Project	IEEE 802.16 Broadband Wireless Access Working Group < http://ieee802.org/16 >	
Title	Figure 470, comment#62	
Date Submitted	2007-01-17	
Source(s)	Aik Chindapol, Achim Brandt Siemens Networks	Achim.brandt@siemens.com
Re:		
Abstract	Change to Figures 470, section 14.1.3, page 35 – in support of comment #62	
Purpose	Adoption	
Notice	This document has been prepared to assist IEEE 802.16. It is offered as a basis for discussion and is not binding on the contributing individual(s) or organization(s). The material in this document is subject to change in form and content after further study. The contributor(s) reserve(s) the right to add, amend or withdraw material contained herein.	
Release	The contributor grants a free, irrevocable license to the IEEE to incorporate material contained in this contribution, and any modifications thereof, in the creation of an IEEE Standards publication; to copyright in the IEEE's name any IEEE Standards publication even though it may include portions of this contribution; and at the IEEE's sole discretion to permit others to reproduce in whole or in part the resulting IEEE Standards publication. The contributor also acknowledges and accepts that

3 **Figure 470 – SAP Service primitive Flow Diagram Template. Four typical handshake scenarios shown here.**
 4 **The procedures are applicable to BS and MS side.**

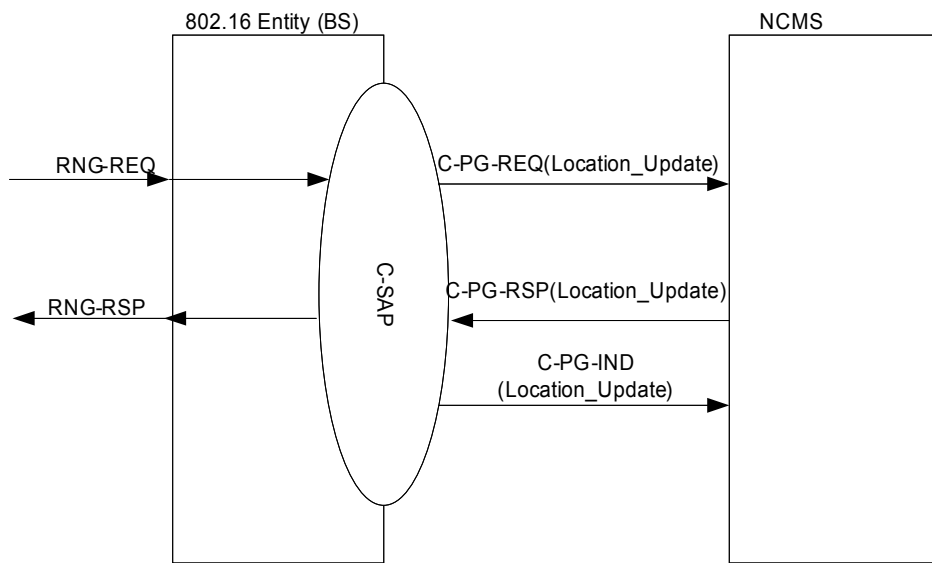
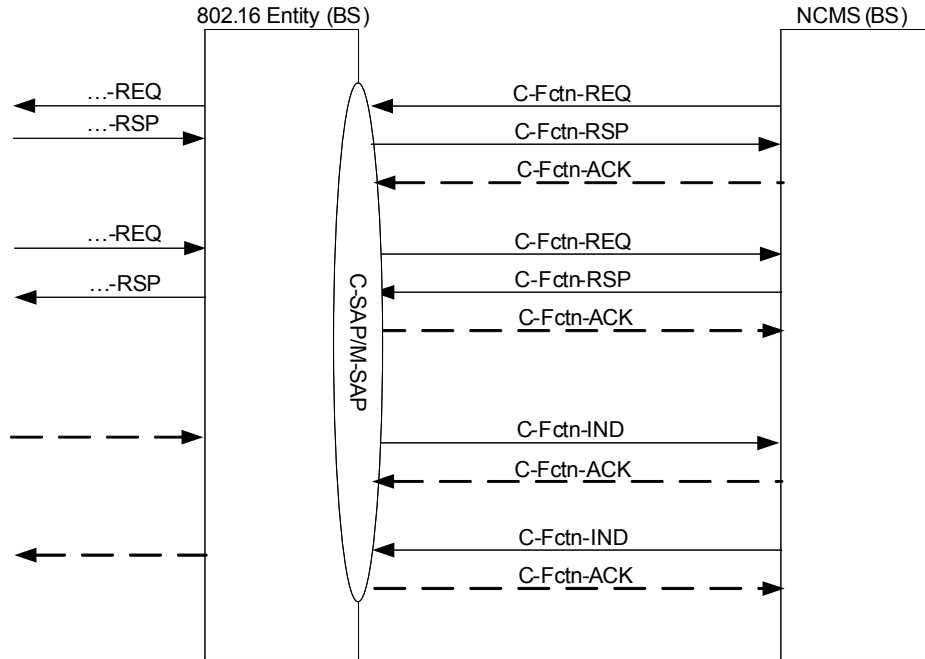
2 Figure 470, the SAP Service Flow Diagram Template, currently is not consistent with the way how the four primitive types
3 are used throughout section 14.2. E.g. the IND primitive is in fact used in both directions etc. Comment #62 therefore
4 proposes to update Figure 470. At the same time, comment #62 aimed at adopting the standard usage of service primitive
5 types REQ, RSP, IND, CFM as defined e.g. in IEEE 802.2. Since section 14 currently applies the primitive types differently,
6 the alignment of the primitive types to that of 802.2 would cause changes to all of section 14.

7 This contribution proposes a less radical change: It includes a proposed remedy for comment#62 which is in line with the
8 current usage of the primitives in section 14.2. The current primitive types REQ, RSP, IND and ACK are maintained. Some
9 text is proposed which states the underlying primitive design rules explicitly.

10 It is proposed to accept the changes for section 14.1.3 as shown below.

5 The figure is illustrative only and provides an example of correct formatting of primitive figures.

8 On page 31, before line 54, insert the following text:

9 A service primitive of type REQ is used whenever a response to the primitive is solicited. If there is a REQ message
 10 on the radio interface, it is generally mapped to a REQ on C-SAP/M-SAP.

11 A service primitive of type RSP is used in response to a REQ primitive. Moreover, if there is a RSP message on the
 12 radio interface, it is generally mapped to a RSP on C-SAP/M-SAP.

13 A service primitive of type IND is used at C-SAP or M-SAP for event notification if a response to this primitive is
 14 not solicited, and if the primitive is not sent in response to a REQ primitive.

15 A service primitive of type ACK can be used to acknowledge the receipt of a C-SAP primitive of type REQ, RSP or
 16 IND.
